TO: Marlborough Conservation Commission DATE: April 30, 2020
Revised May 13, 2020

SUBJECT: 608647, Marlborough – Resurfacing and Related Work on Route 20
Response to Marlborough Conservation Commission Questions

The purpose of this memorandum is to provide a summary response to the questions raised by the Marlborough Conservation Commission at the April 9, 2020 public hearing for the Notice of Intent filed for the Marlborough Route 20 project. The following questions raised by the Marlborough Conservation Commission will be addressed by this memorandum:

**GRADING PLANS
SHEET 12 OF 27**

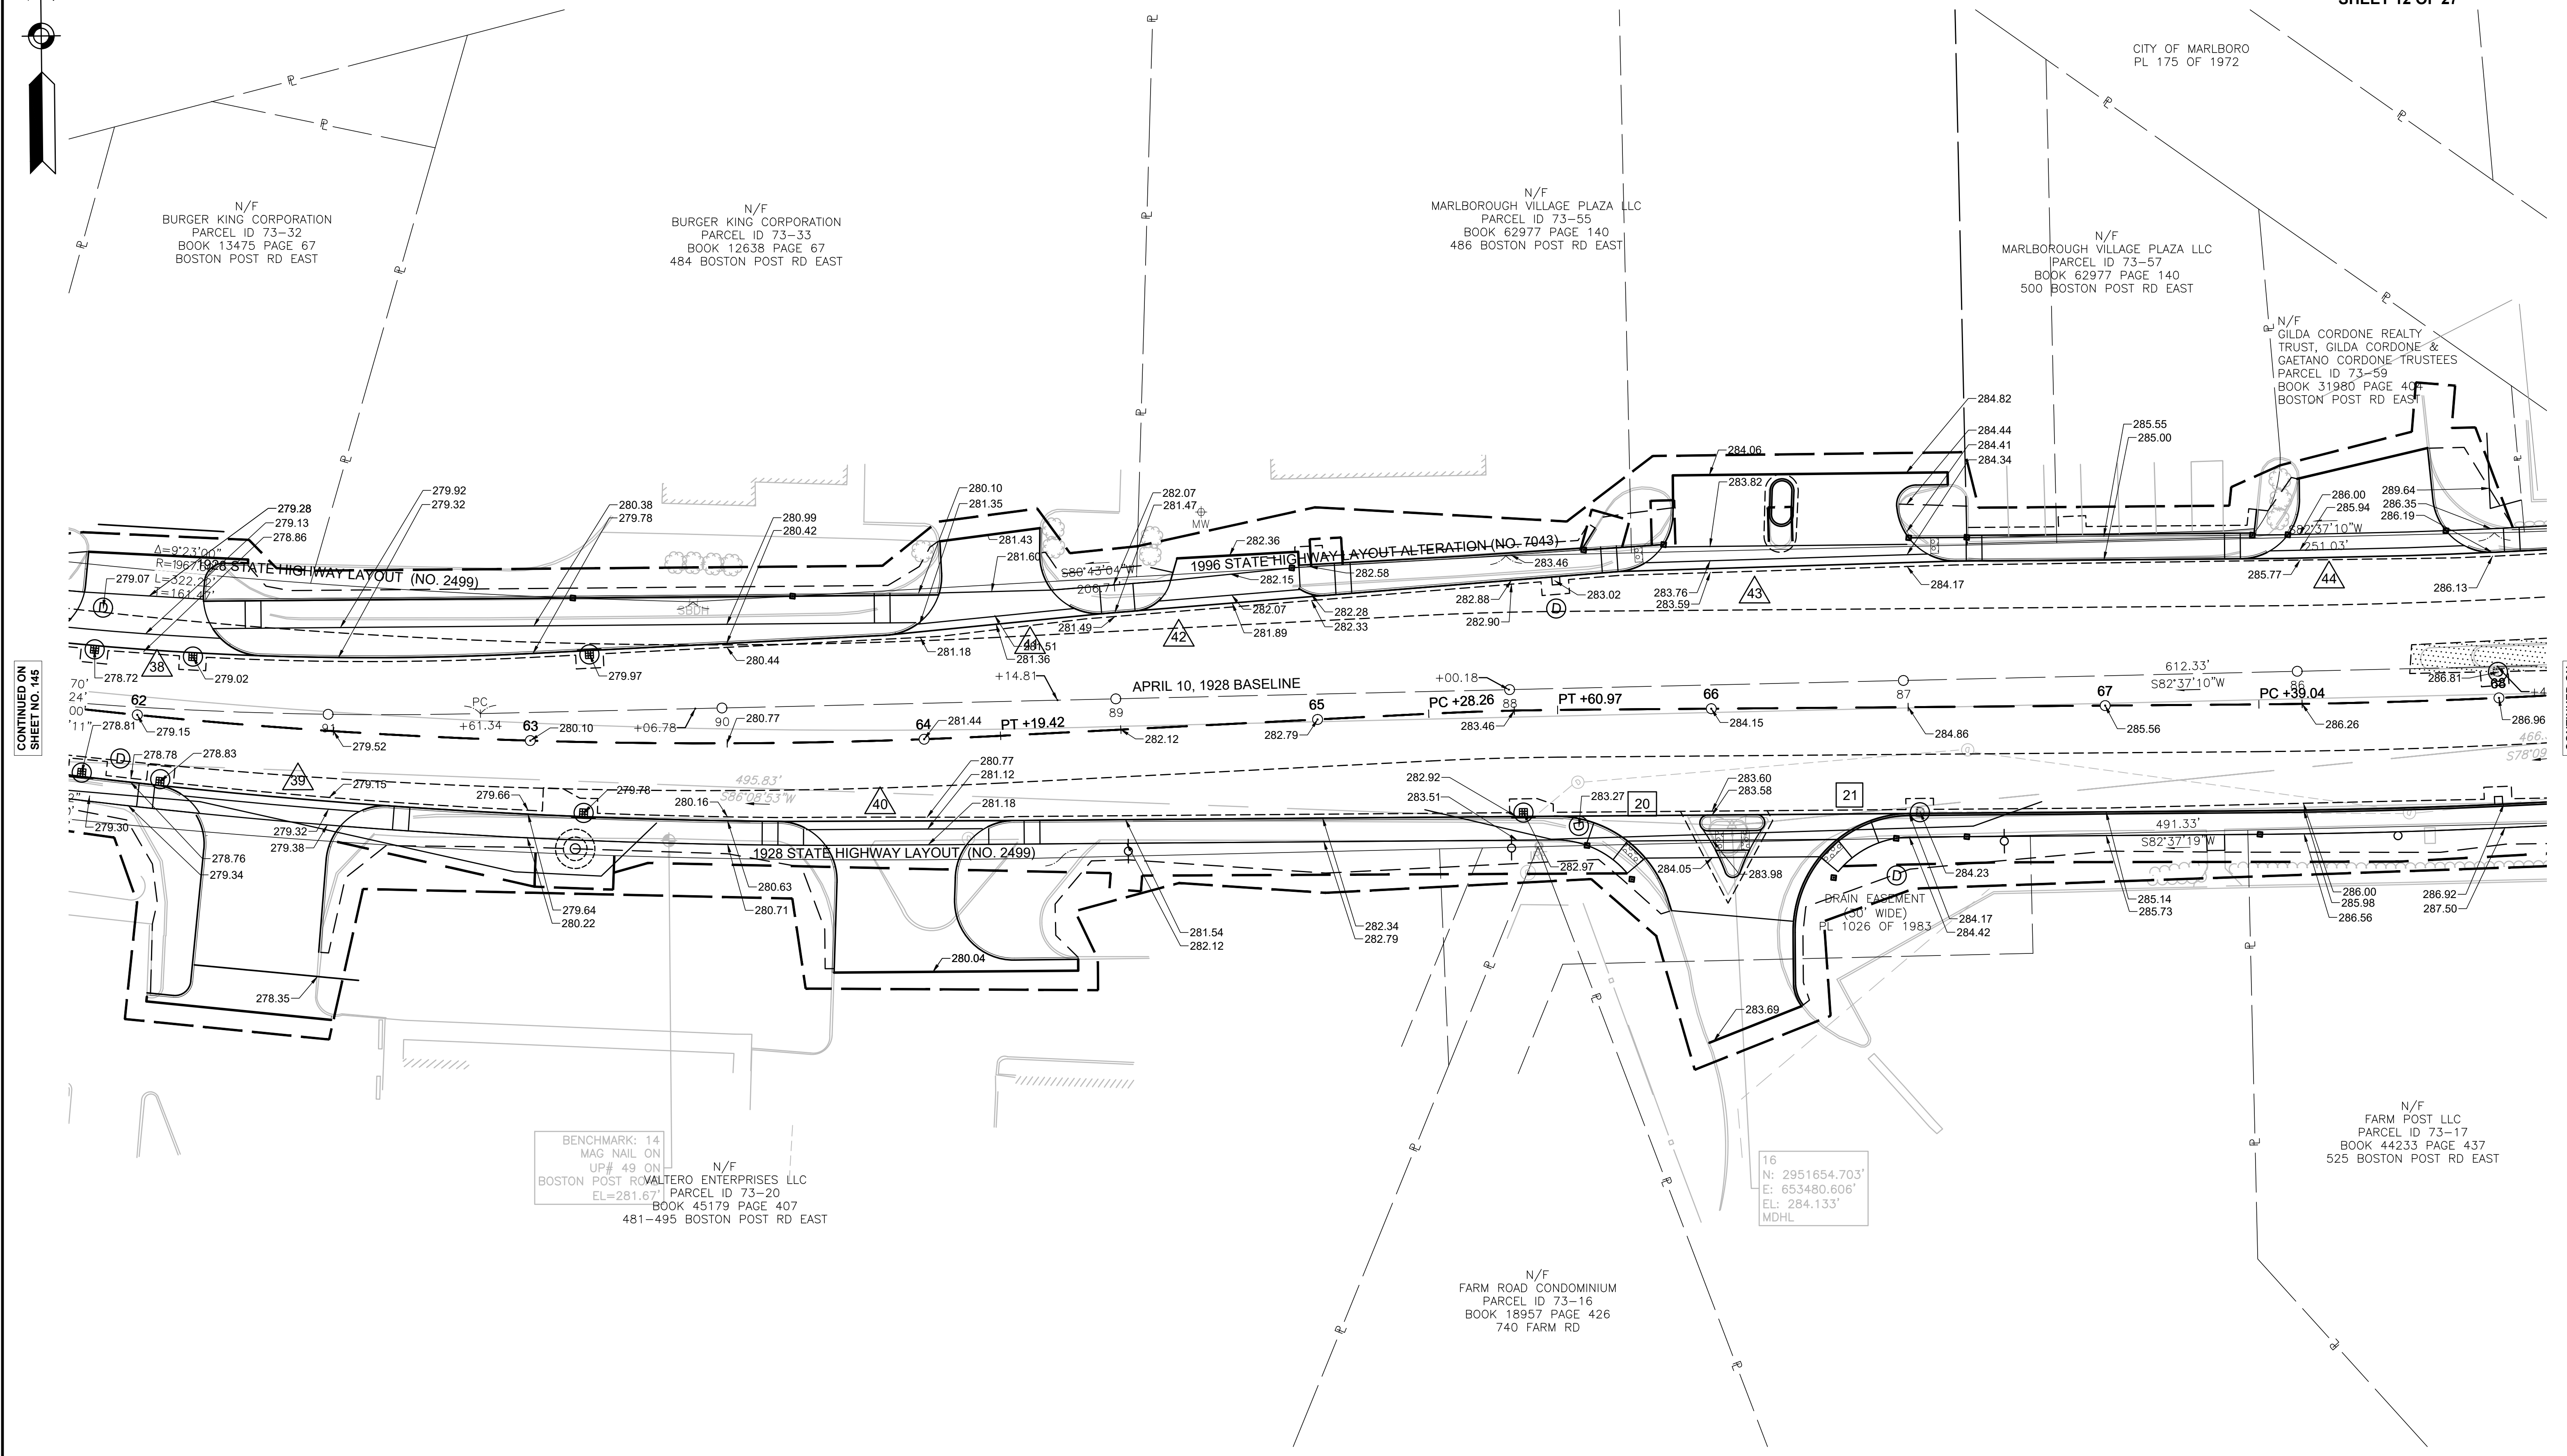
Marlborough Conservation Commission Comment / Question 2: Verify the proposed design prevents water from ponding along the gutter line in front of Burger King.

Upon review of the grading plans in this area it has been confirmed that the project is designed to prevent water from ponding along the gutter line in front of Burger King. Along this section of the road the gutter line is continuously sloped / graded to drain from east to west along the gutter line in front of Burger King. Within this section of the road there are catch basins proposed; a.) approximately 100 feet east of the Burger King property and its eastern most driveway; b.) another approximately half-way between the 2 Burger King driveways; and c.) two more at the western most Burger King driveway, where the road grade transitions upgradient in the opposite direction.
